Project: Fillmore High School Modernization

Project Number: WGD 20624 DSA# 03-121233

Addendum 03 – Mechanical Unit Replacement

Date: September 8, 2023

E004 – Single-Line Diagram

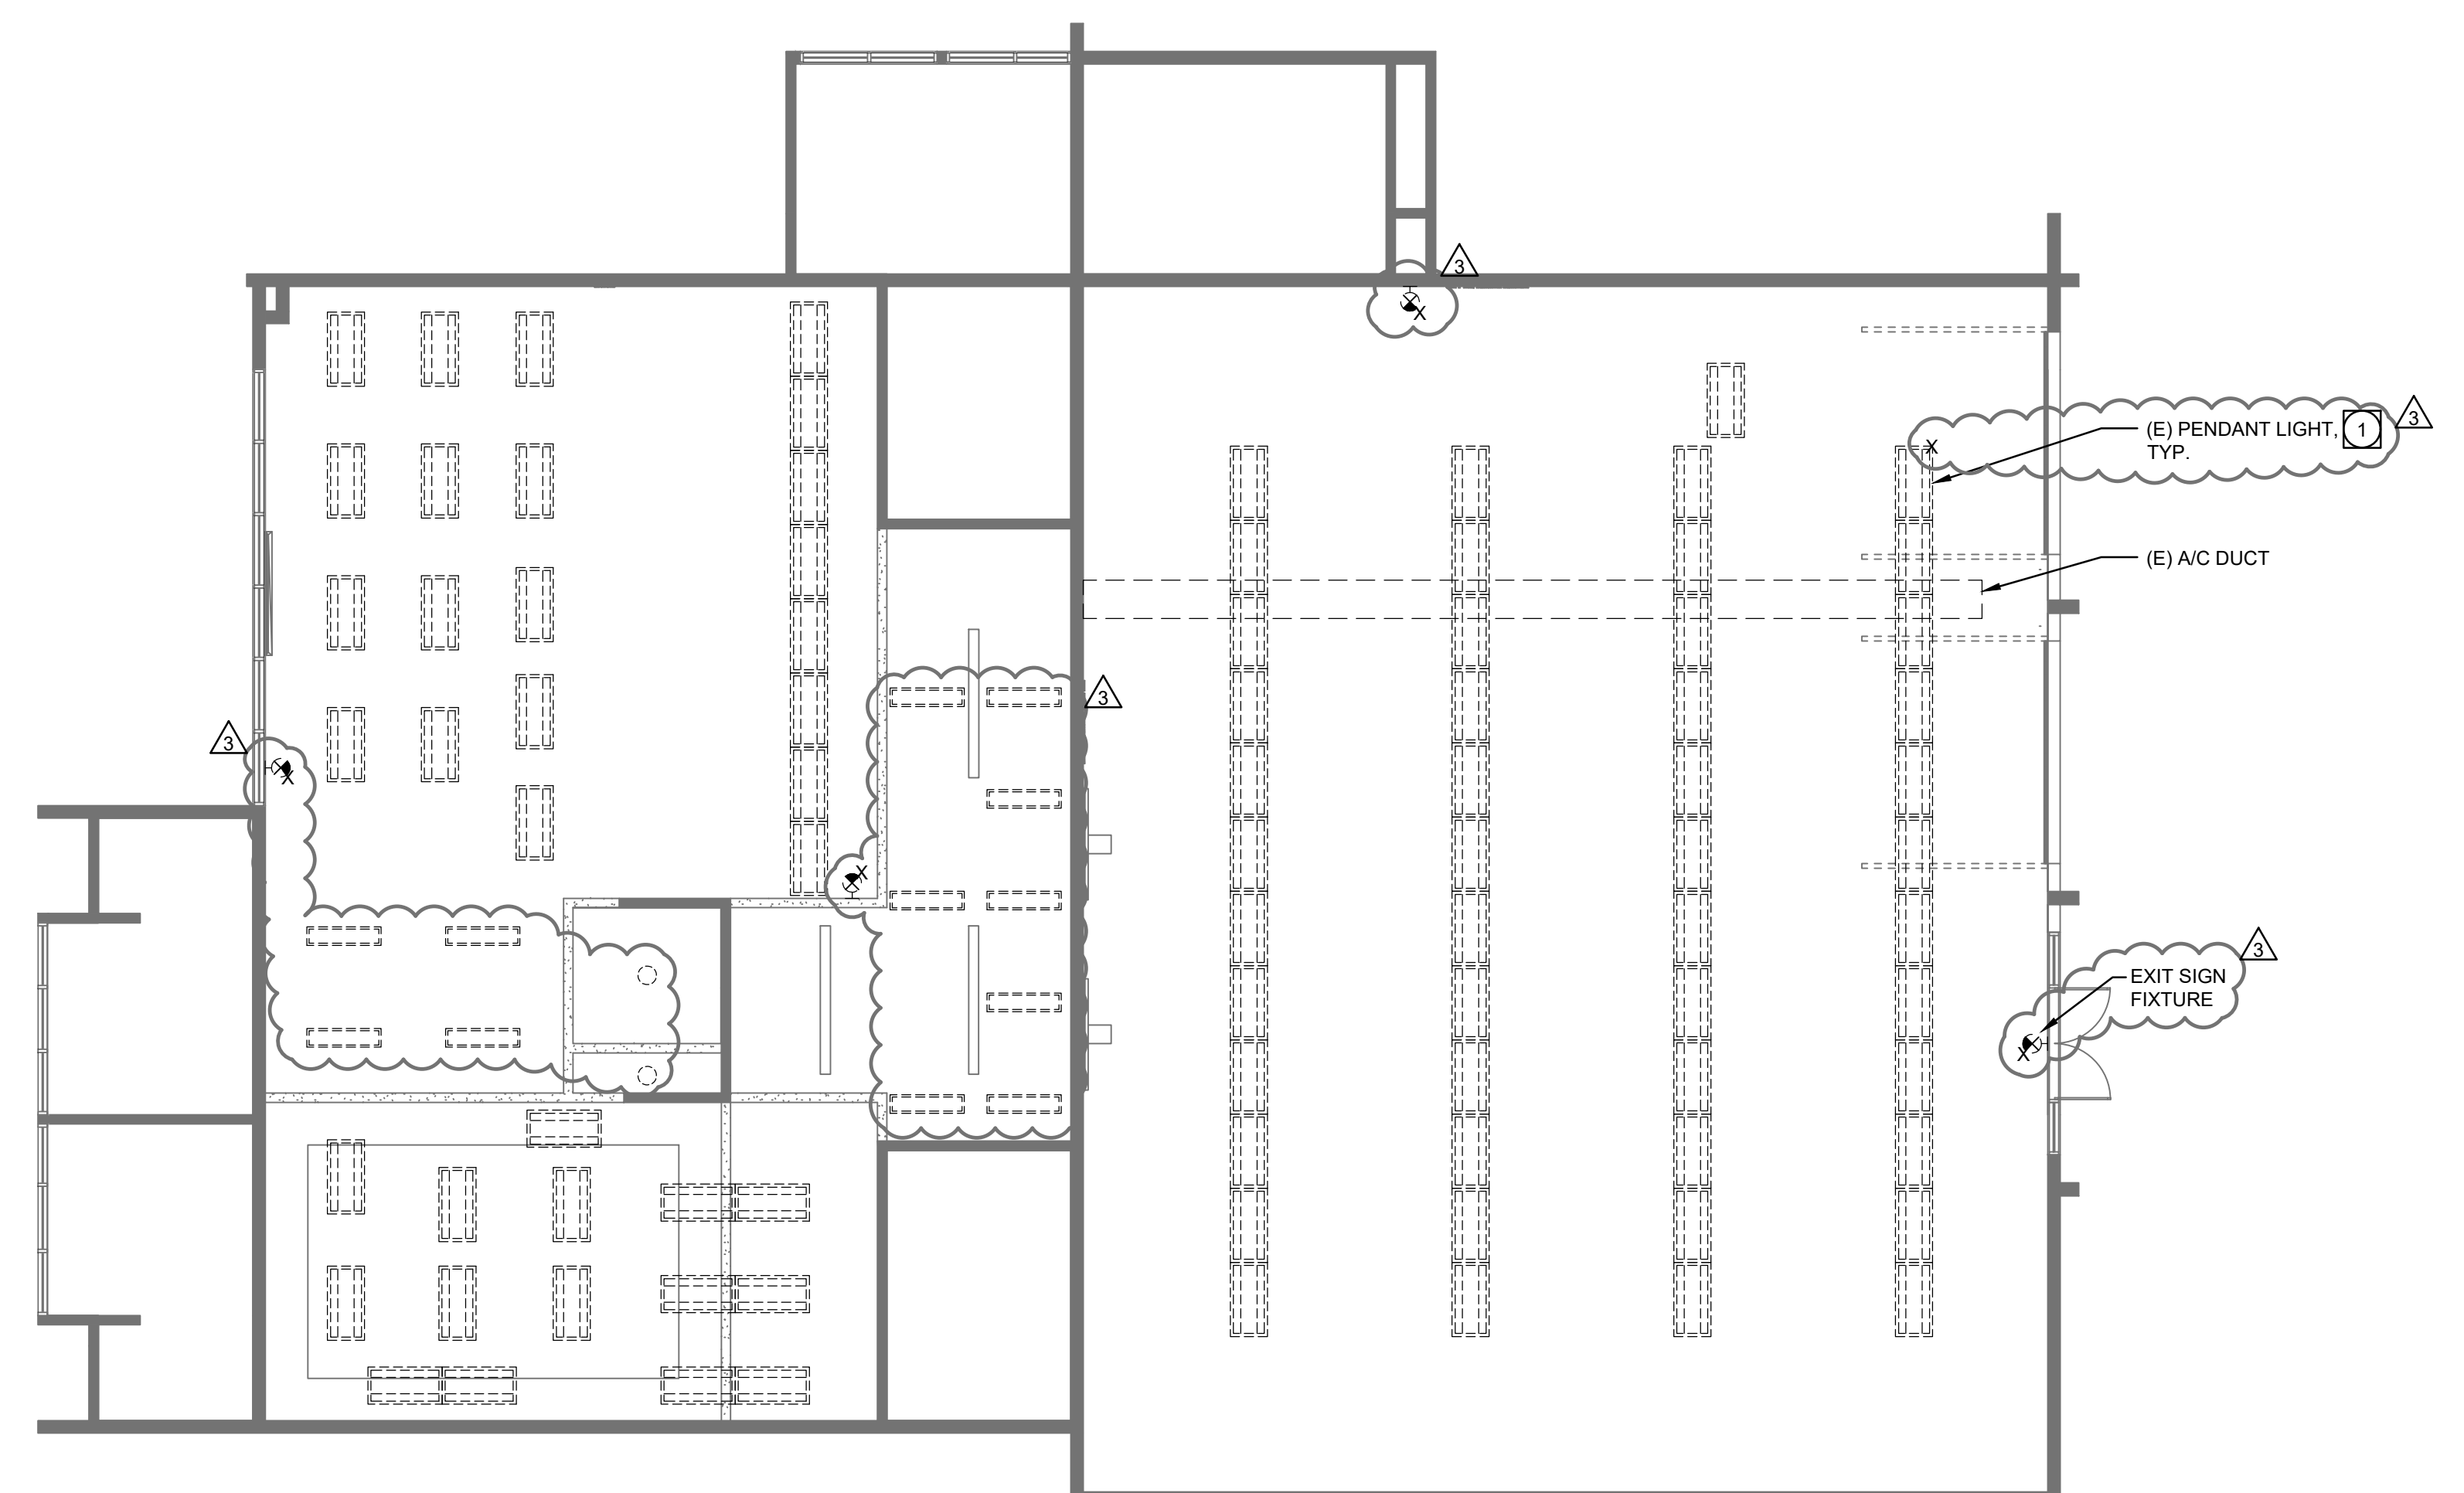
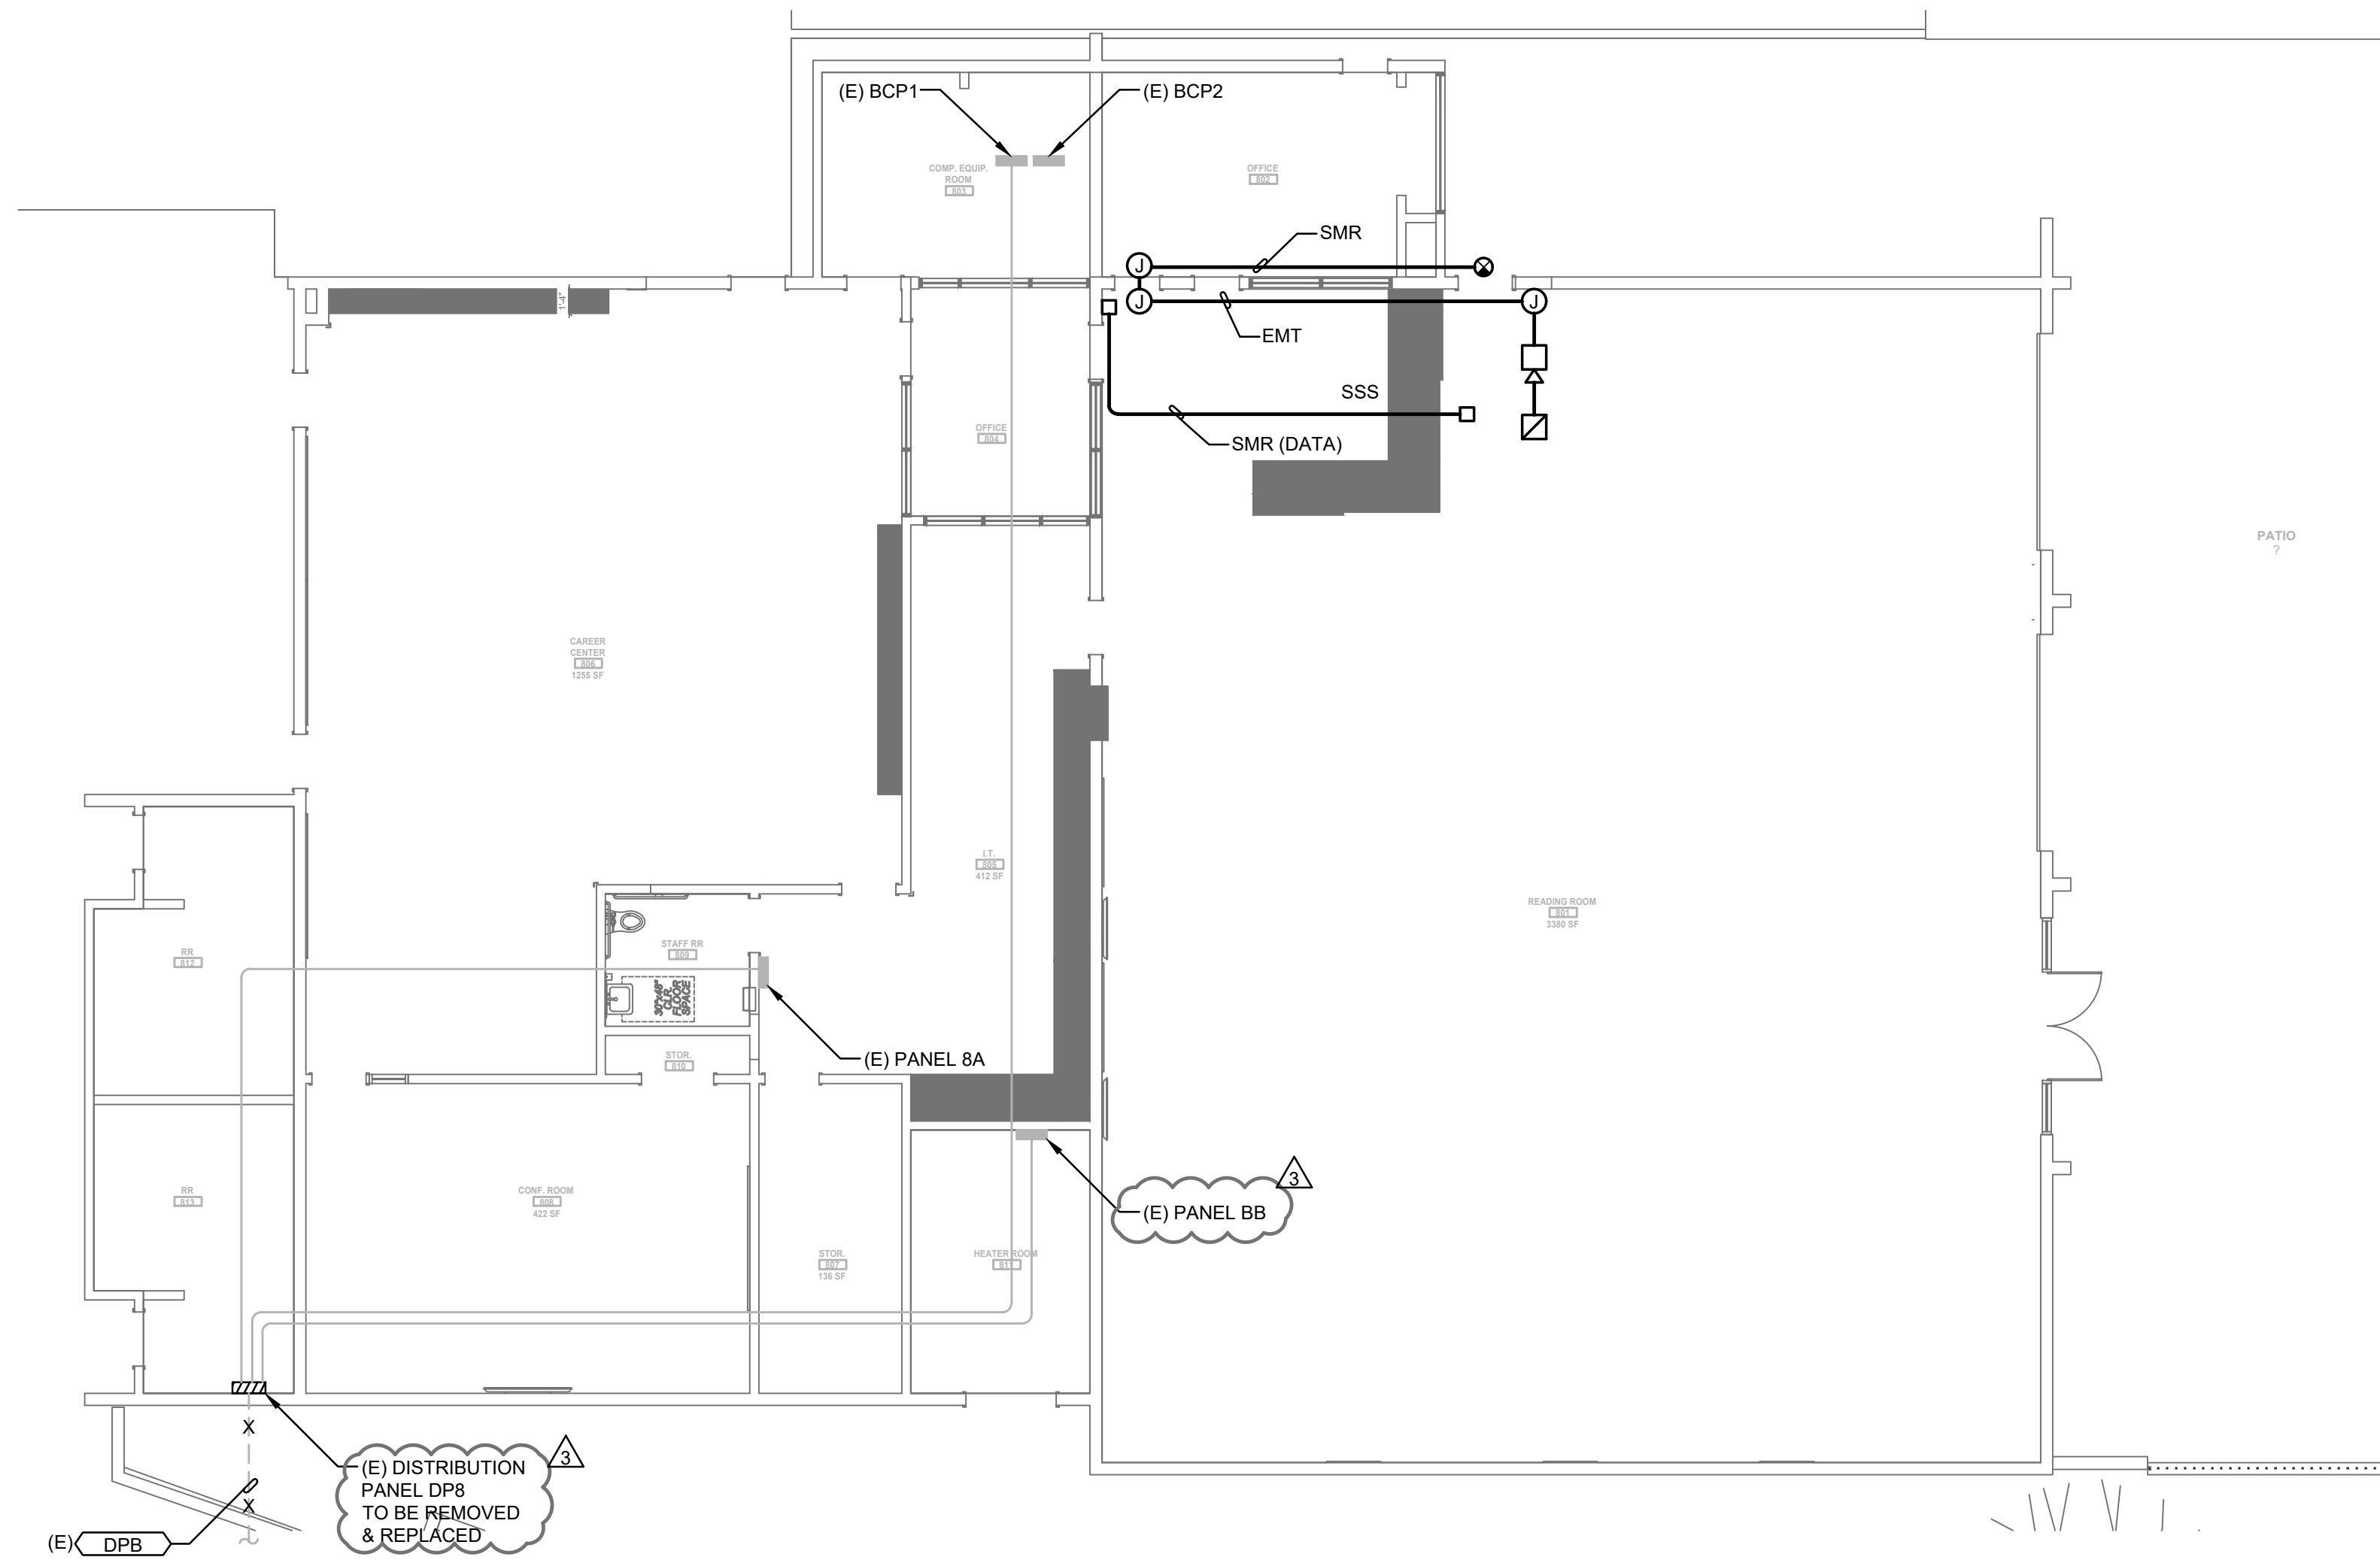
- a. Modify electrical distribution system feeding building 8 & 9.
